Product Change Notification

Product Change Notification: E-20-007322

RJ45 CONNECTOR CAT6A, IP20 PLUG & VARIANT 14; METAL PLUG, RJ45,CAT6A,8POS.

Terminal Housing for Common core Before Change

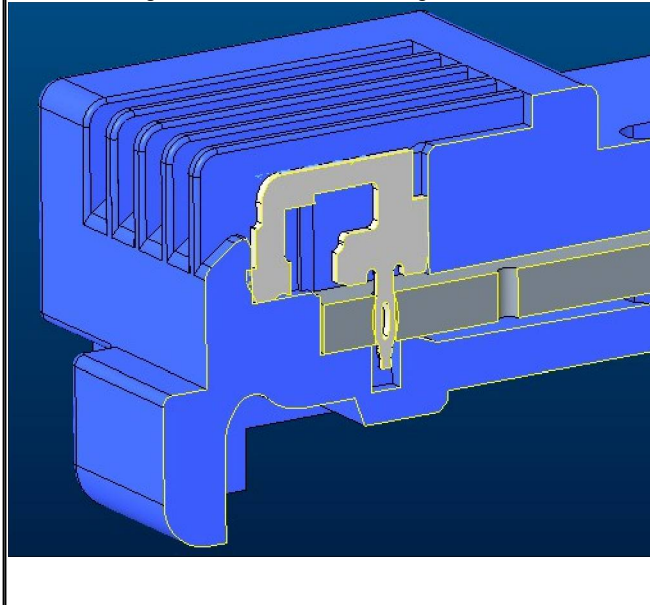
Plastic material will be added to the inner sides of the eight contact chambers within the Terminal Housing to support a smoothly filling of chamber walls and their stabilization. The dimensions acc. to the IEC standard are stronger supported. After a release, please expect a mix of connectors. The new and old design does not have any impact on the functionality. Please note that there will be no physical change on following products except revision letter change: PN 2120864-1, 2-2120864-1, 3-2120864-1, 4-2120864-1 and 2120875-1, 2-2120875-1, 3-2120875-1, 4-2120875-1, 5-2120875-1, 6-2120875-1, 7-2120875-1, 8-2120875-1.
